Response to RC1

Wang et al. simulated CO₂ mole fractions over Western Europe in the summer of 2018 using the WRF-Chem model combined with three different CO₂ emission inventories. The simulations were evaluated by comparing with ground-based in situ and column observations. They showed, by taking into account the sector-specific vertical profiles of emissions, the agreement between the simulations and the observations was significantly improved for sites near large emission sources.

Response to RC2

Figure A. Time series (local time) of observed and simulated XCO₂ using TNO inventory at Paris and Orléans TCCON sites (b), and their absolute differences (WRF-GHG - TCCON) (a).

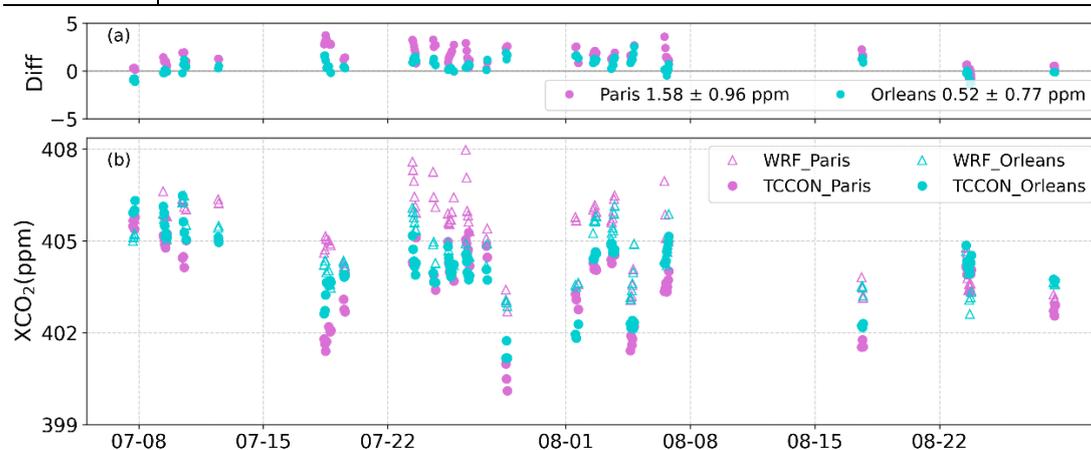
6. 338–347: If the data period for Orleans was matched with that for Paris, would similar results be obtained? In other words, would the difference between Paris (an urban area) and Orleans (a suburban area) be reflected in the observed XCO₂?

We selected the data points where the observation times at the Orléans and Paris sites overlap, resulting in a sample number of 94. The statistical metrics between the simulated and observed XCO₂ at the Paris and Orléans site are given in the Table A, and the time series of observed and simulated XCO₂ using TNO inventory at Paris (magenta) and Orléans (teal) TCCON sites are shown in Figure A.

It can be found that, for this selected time series, compared to the large differences caused by using different emission inventories at the Paris site (up to approximately 0.49 ± 0.33 ppm between TNO and EDGAR), differences are also present at the Orléans site but are smaller (up to approximately 0.1 ± 0.08 ppm between TNO and CAMS). The simulated XCO₂ at the Orléans site (a suburban area) shows a systematic overestimation (around 0.4 - 0.5 ppm), but its magnitude is obviously lower than that at the Paris site (an urban area, around 1.1 - 1.6 ppm). As the anthropogenic emissions around Orléans are relatively low (Figure 9 in revised manuscript), it indirectly suggests that, in addition to uncertainties in the background fields, the overestimation at the Paris site is to a large extent caused by uncertainties in the anthropogenic emissions.

Figure B. Diurnal cycles (local time) of simulations with different anthropogenic emissions at five ICOS sites at the model lowest layer (approximately 25 m above the ground).

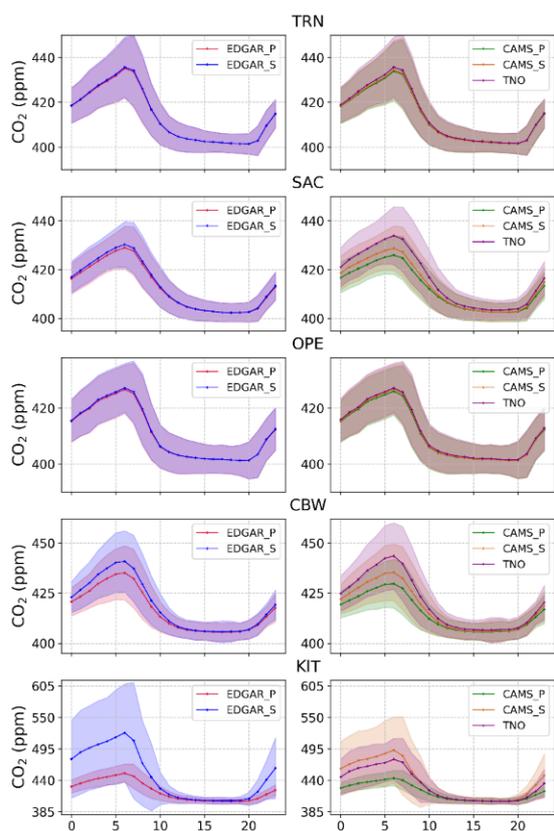
8. L382–383: In Figure 10, it appears that there are also large emission sources near sites other than KIT (i.e., CBW and SAC). What degree of closeness does “near” represent?

Yes, in addition to the KIT site, there are also strong emission sources near the CBW and SAC sites. Figure B shows the simulated near surface CO₂ mole fractions at the lowest model level at each site, which is located at approximately 25 m above the ground. It can be found that at the TRN and OPE sites, the five simulated results are almost identical, which is consistent with the relatively weak anthropogenic emissions

in their vicinity. At the SAC and CBW sites, whether vertical emissions are taken into account indeed has an impact on the simulation results. Because the emission sources near the SAC site are comparatively weaker, the differences among the results there are also smaller. However, the sensitivity tests at the observation heights of SAC and CBW do not show significant biases. For SAC, this may be because the emission sources are not as strong. For CBW, this may be because the observation height used is relatively high (207 m above the ground). As shown by the results at different heights at the KIT site, the higher the observation height, the smaller the difference between simulations that consider only surface emissions and those that include vertical emissions.

We have added “as well as near the CBW and SAC sites, whereas there are almost no emission sources in the vicinity of the TRN and OPE sites. Figure A4 shows the diurnal cycles of the five near-surface CO₂ mole fractions at each ICOS site as simulated by WRF-GHG fractions at the lowest model level (approximately 25 m above ground level). It can be found that at the TRN and OPE sites, the five simulations show nearly identical

patterns, consistent with the relatively weak anthropogenic emissions in their surrounding areas. In contrast, at the SAC and CBW sites, whether vertical emissions are taken into account does indeed affect the simulations. However, at the observation heights of these two sites, the impact is small and does not exhibit characteristics similar to those observed at the KIT site. For the SAC site, this may be due to the relatively weaker emission sources nearby, whereas for the CBW site, this may be related to the relatively high observation height used (207 m above ground level), as shown for the KIT site (Fig. 4), the discrepancies between sensitivity tests decrease with increasing observation height” to lines 391-400 of the revised manuscript. In addition, Figure B has been incorporated into the revised manuscript as Figure A4.

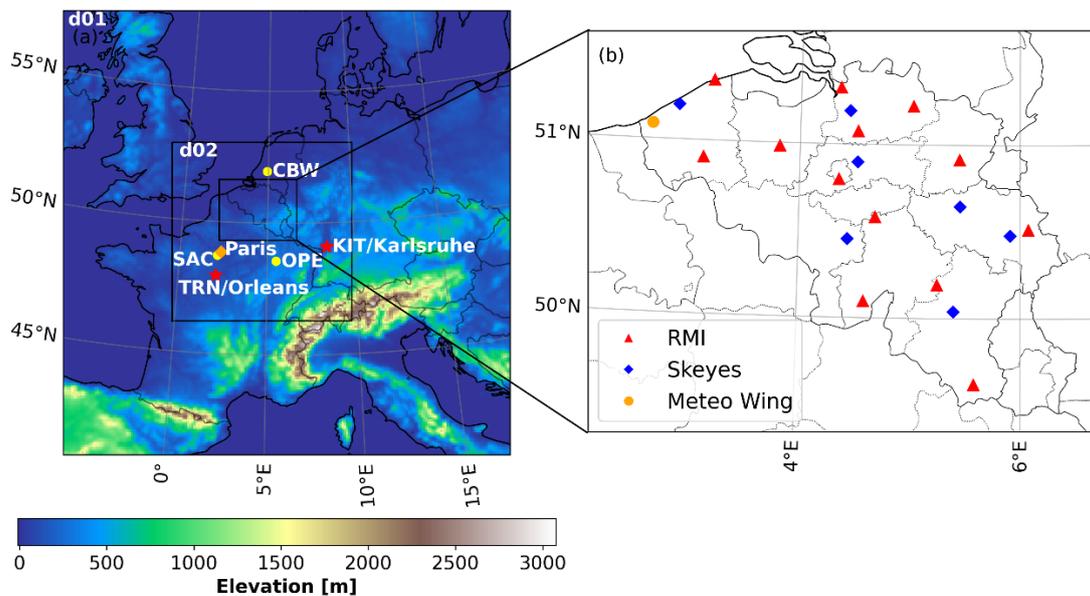
3. I think Figures 1 and 2 can be combined.

Done. The figure has been revised as follows.

Figure A. The diurnal cycles (local time, UTC+2) of planetary boundary layer height simulated by WRF-GHG (red) and ERA5 (blue) at the KIT (a), the TRN (b), the SAC (c), the OPE (d) and the CBW (e) sites.

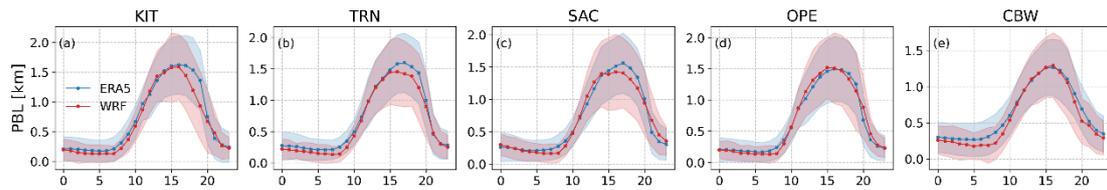
8. Figure 3. What are the sunrise and sunset times in these ICOS stations? The highest temperature occurred at 18:00 local time, and the PBL reached its maximum height between 15:00-17:00 (line 319). It seems unreasonable.

We thank the reviewer for this comment. During the simulation period, according to NOAA Solar Calculator, the sunrise at the ICOS sites involved in our study occurs around 5:00 - 7:00 (local time), and sunset occurs around 20:00 - 22:00, and the sun reaches its highest position around 14:00 LT at most sites (energy saving time, UTC+2).

We have double-checked. As shown in Figure 2 of the revised manuscript, the simulated diurnal variation of temperature is consistent with observations. For the PBL, we extracted the corresponding PBL data from ERA5. Figure A presents the diurnal cycles of the PBL provided by ERA5 (blue) at each ICOS site. It can be seen that, at all sites, the diurnal variation of the PBL simulated by the WRF model is generally consistent with that from ERA5. Therefore, the consistency with observations and ERA5 data

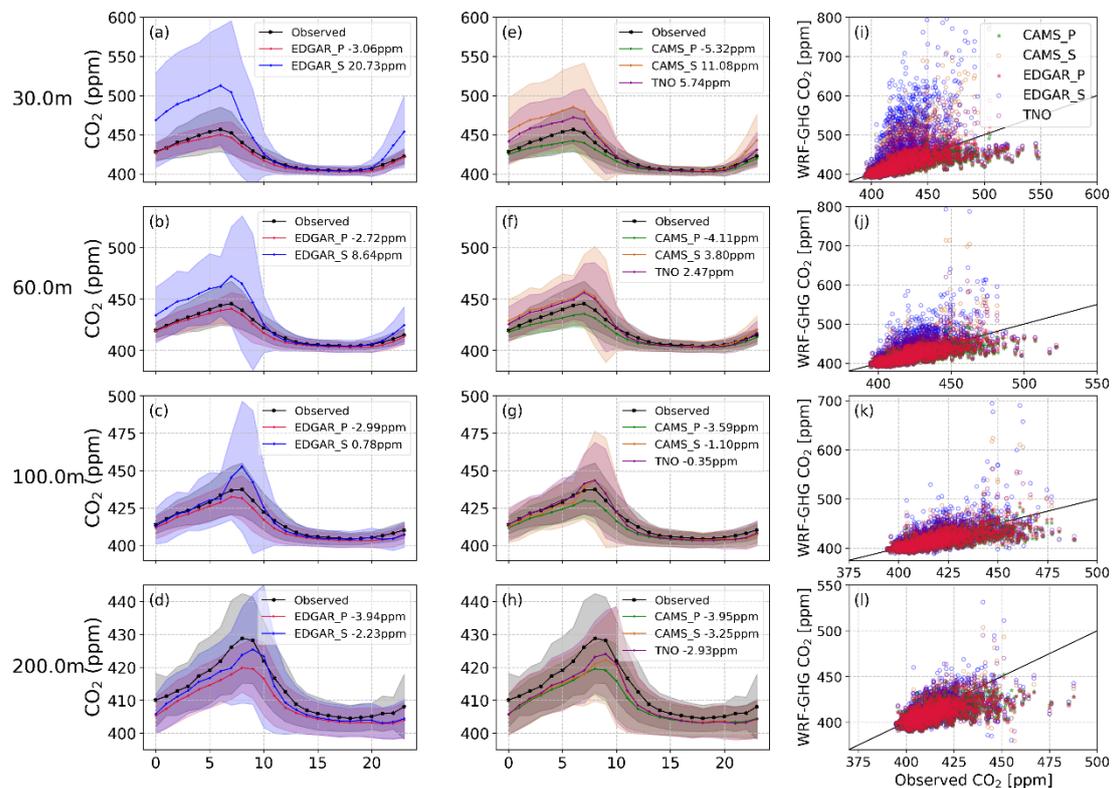
9. Figure 5. I think it is better to keep the y-axis of CO₂ concentrations the same across different emission inventories at the same height.

Done. The figure has been revised as follows.

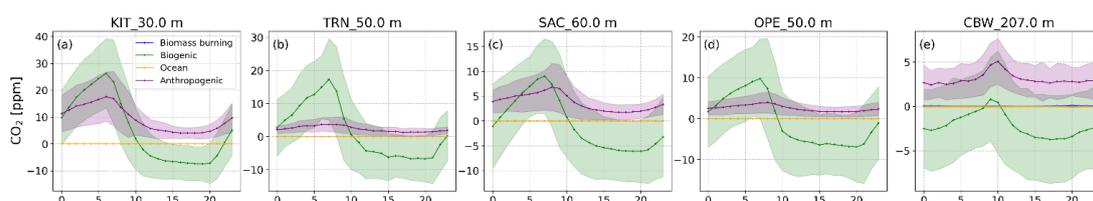
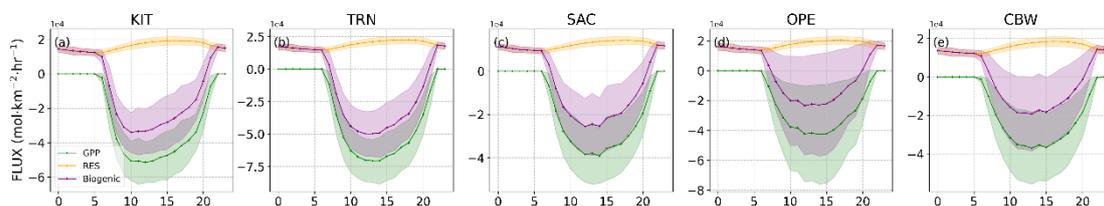
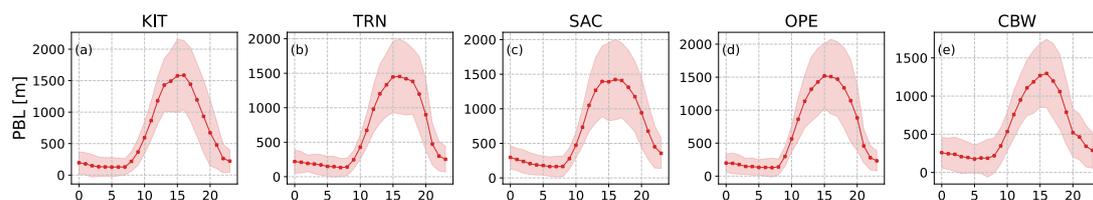
10. Figure 6. It seems there is no contribution from biomass burning in these figures. Why are biogenic contributions nearly negative from 10:00- 23:00 at all sites? Why are biogenic contributions only positive around 10:00?

The contributions from biomass burning and the ocean are both nearly zero; therefore, in Figure 6 (Figure 5 in revised manuscript), the biomass burning values are overlapped by the ocean contribution, making them appear not to be shown.

Across all sites, during the local time period of approximately 10:00 - 23:00, the biogenic contribution is nearly negative. This behavior is primarily attributed to the fact that daytime CO₂ uptake by vegetation through photosynthesis is substantially stronger than ecosystem respiration. As shown in the diurnal cycle of biogenic fluxes (Figure B), gross primary productivity (GPP) increases rapidly after sunrise (05:00 - 07:00) and acts as a strong negative flux. Its magnitude clearly exceeds that of respiration (RES) during the daytime, resulting in a net negative biogenic CO₂ flux, which indicates that terrestrial ecosystems act as a net sink of atmospheric CO₂. The period from sunrise to approximately 10:00 corresponds to the morning transition phase. During this period, photosynthesis gradually intensifies while respiration continues. Due to CO₂ accumulation caused by nighttime respiration under shallow PBL conditions, the biogenic contribution to near-surface CO₂ concentrations during this period remains positive. However, as photosynthesis strengthens, the overall biogenic contribution to near-surface CO₂ concentrations exhibits a decreasing trend.

Around 10:00 - 11:00, photosynthesis is strong at all sites, and the total biogenic flux reaches a strong CO₂ uptake (Figure B), and simultaneously, the PBL height starts rising rapidly (Figure A3). At this time, photosynthetic CO₂ uptake largely offsets the CO₂ accumulated from nighttime respiration. Subsequently, as the biogenic flux remains in a net uptake regime throughout the daytime, the biogenic contribution to near-surface CO₂ concentrations remains stably negative from daytime until approximately 20:00.

After 20:00, as photosynthesis weakens and ecosystem respiration becomes dominant again, the total biogenic flux gradually shifts to positive values. Meanwhile, the height of PBL decreases, facilitating the accumulation of respiration-derived CO₂ near the surface. Consequently, the biogenic contribution to near-surface CO₂ concentrations transitions from negative values toward zero and largely compensates for the daytime uptake by around 23:00.

We apologize if we may not have fully understood the reviewer's question. We infer that the last question may be: *Why are the biogenic contributions at the CBW site only positive around 10:00, whereas other sites show a different pattern?* For the CBW site, the biogenic contribution is only positive around 9:00-10:00, in contrast to the other sites where positive values most persist from 01:00 to 10:00. This difference may be attributed to the higher observation height at the CBW site (207 m above ground), whereas the observation heights at the other sites are around 50 m. At night, CO₂ released by respiration remains difficult to transport to the observation height of 207m because the nocturnal PBL is shallow and the atmospheric stratification is relatively stable (as shown in Figure A3(e), where the height of PBL at night is mostly below 200m). The positive value around 9:00-10:00 is likely caused by the onset of vertical mixing and the rise of PBL height, which transports CO₂ accumulated within the nocturnal boundary layer upward to the observation height. Before 9:00, the observation height is decoupled from the nocturnal boundary layer and is not influenced by nighttime accumulation and respiration, but rather by the remainder of the daytime uptake (residual layer), resulting in negative concentrations. After 10:00, as the PBL gradually deepens during the daytime and vertical mixing is enhanced, near-surface CO₂ is transported to higher altitudes. However, during this period, photosynthetic CO₂ uptake dominates, and thus the observed CO₂ concentration changes are predominantly negative.

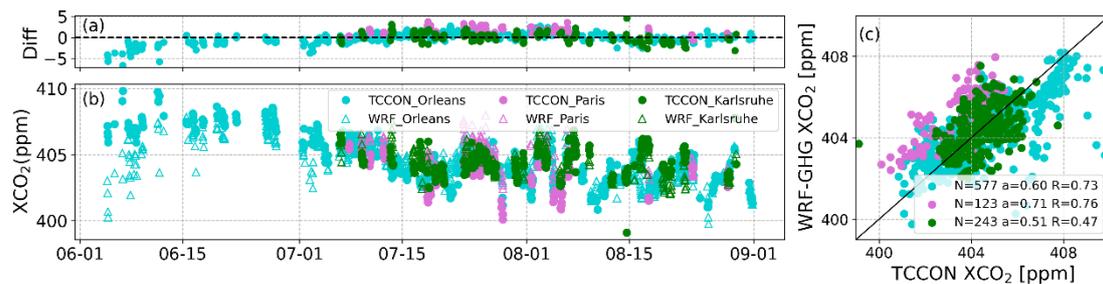
11. Figure 7. It is better to give the slope and correlation coefficient in Figure 7c for the three TCCON sites.

We appreciate the reviewer's suggestion. We have revised the figure as follows.

Figure C. Map of total anthropogenic emissions from CAMS-REG-ANT and EDGAR v2024 in 2018.

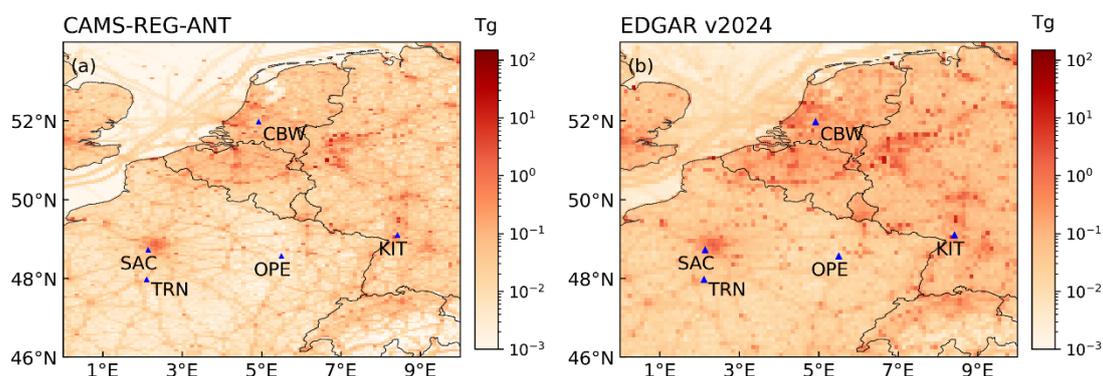
14. Figure 11. There is a large gap between SNAP 1 for CAMS and EDGAR. Figure

10d also showed more emission sources than Figure 1a. Why did this gap occur? Were the emissions included in other emission sectors in CAMS?

The sectoral classifications of anthropogenic emissions differ between CAMS-REG-ANT and EDGAR. In CAMS-REG-ANT, anthropogenic emissions are categorized into 12 sectors (A - L) according to Gridded Nomenclature For Reporting (GNFR) categories, whereas EDGAR v2024 classifies anthropogenic emissions into 8 sectors.

In order to be able to apply vertical profiles to them, we mapped them to sectors classified according to the Selected Nomenclature for Air Pollutants (SNAP), which comprises a total of 10 sectors. However, due to the inconsistent criteria used for sectoral allocation in EDGAR and CAMS-REG-ANT, there may be some degree of cross-sectoral overlap between these datasets during the mapping process.

Besides, we also plotted the maps of the total annual anthropogenic emissions from CAMS-REG-ANT and EDGAR v2024 for 2018 (see Figure C), respectively. It can be seen that the annual emissions provided by EDGAR are significantly higher than those from CAMS.

Figure D. Time series of monthly anthropogenic emissions from EDGAR v2024 at the Paris (a), Karlsruhe (b), and Orléans (c) sites.

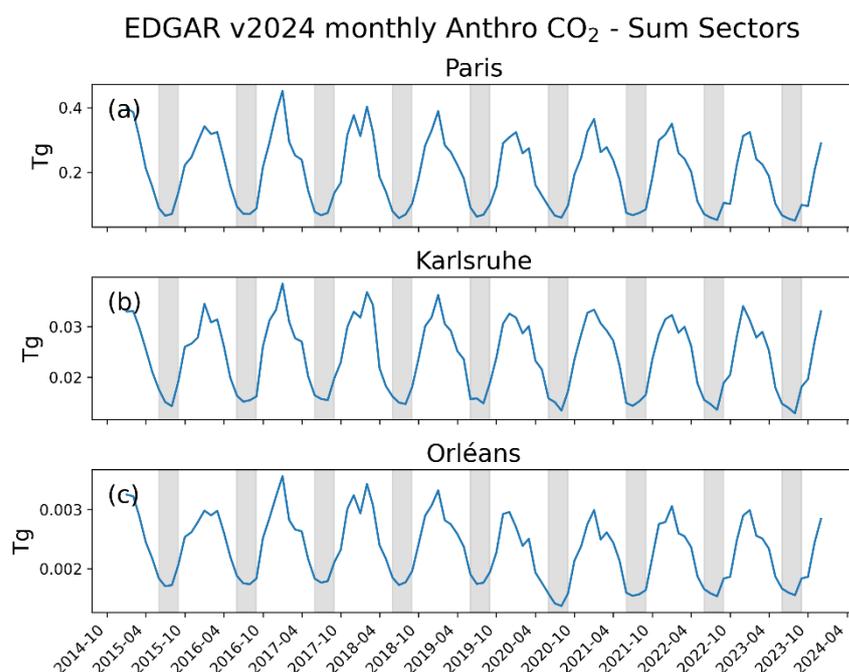
15. Figure 12. It seems that in late July and August, the land system was also active as a carbon source (Figure 12c), but anthropogenic emissions nearly disappeared from Figure 12b. Usually, drought can increase temperatures and the electricity demand for air conditioning, hence the anthropogenic emissions could increase in this period.

We thank the reviewer for this comment. Indeed, there is a carbon source near the surface in July and August for the biogenic tracer which can be seen in Fig. 12c (Figure 11 in revised manuscript), but this feature is less pronounced in Fig. 12b since the latter represents the column-averaged dry-air mole fractions of CO₂. As shown in Fig. 12c, the contribution of biogenic CO₂ decreases with increasing altitude and becomes negligible above approximately 2000 m.

And indeed, drought could increase electricity demand, but air conditioning remains relatively uncommon in Europe, especially in the countries involved in our study. In addition, Figure D shows the time series of monthly anthropogenic emissions from EDGAR v2024 obtained from ECCAD at the Paris (a), Karlsruhe (b), and Orléans (c) sites, respectively. The shaded area represents emissions during June - August of each year. Compared with non-drought years (e.g., 2016 and 2017), anthropogenic emissions in summer 2018 do not exhibit a noticeable increase and are even slightly lower than in those years. Based on these two considerations, the lack of a noticeable increase in simulated anthropogenic emissions during this period is reasonable.
